IDAP REPORT

Property:	38 Pemberton Street, Strathfield Lot 190 DP 15259 DA2021.112
Proposal:	Demolition of existing structures and construction of a two (2) storey dwelling house, detached secondary dwelling, in-ground swimming pool and associated landscaping works.
Applicant:	A Chen
Owner:	S Charoensri & Y W Sun
Date of lodgement:	4 June 2021
Notification period:	09 June 2021 to 25 June 2021
Submissions received:	Three
Assessment officer:	P Santos
Estimated cost of works:	\$1,038,381.00
Zoning:	R2-Low Density Residential - SLEP 2012
Flood affected:	Yes
RECOMMENDATION OF OFFICER:	APPROVAL

Figure 4. Extract of the submitted ground floor plan of the secondary dwelling, drawing # A05, revision L, dated 3/09/2021 (source: AGC Architects P/L).

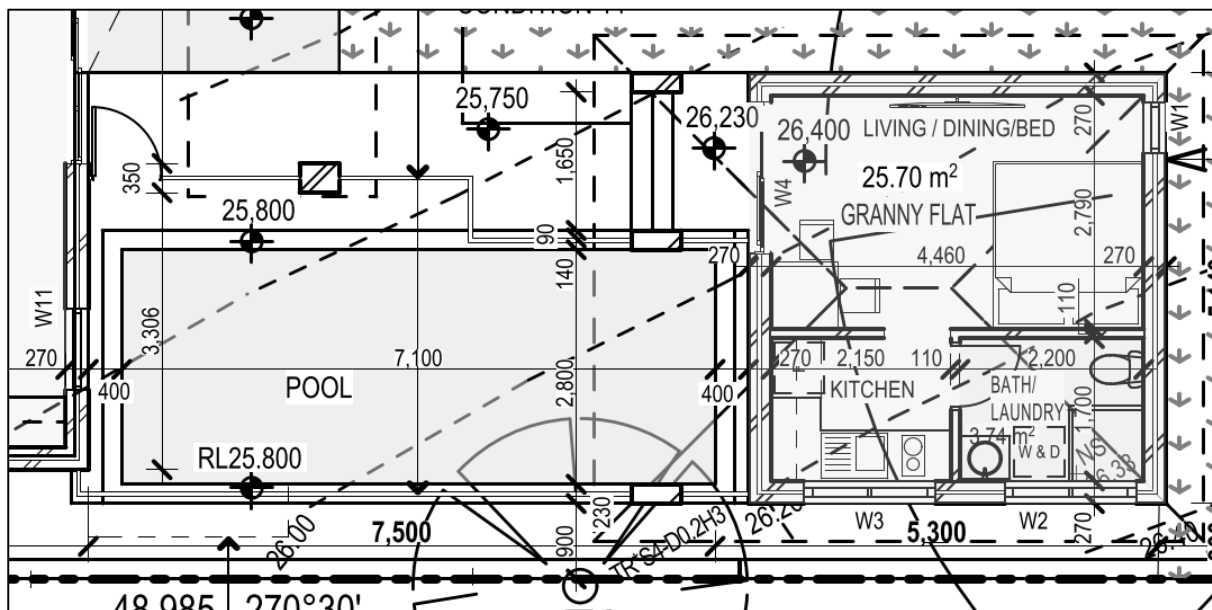
The proposed secondary dwelling has a side setback of 0.9m to the southern side boundary. This presents a 0.6m shortfall from the required 1.5m in the SCDCP 2005. With the location of the kitchen, a heavily-used space in a dwelling, next to the side boundary, the proposed side setback of the secondary dwelling is not acceptable. The proposed side setback not only poses a bulkier appearance when viewed from the adjoining neighbour, but also raises acoustic privacy concerns for being too close to the side boundary.

To ensure that adequate separation between the adjoining property and the secondary dwelling is maintained, a condition of consent will be imposed to move the secondary dwelling and comply with the 1.5m side setback development control.

Secondary Dwelling Setback	Amended plans and details are required to show the secondary dwelling ground floor external wall 0.9m side setback (southern side boundary), increased in distance to 1.5m. This means that the approved secondary dwelling is to be moved to the north to satisfy the 1.5m side setback development control.
----------------------------	---
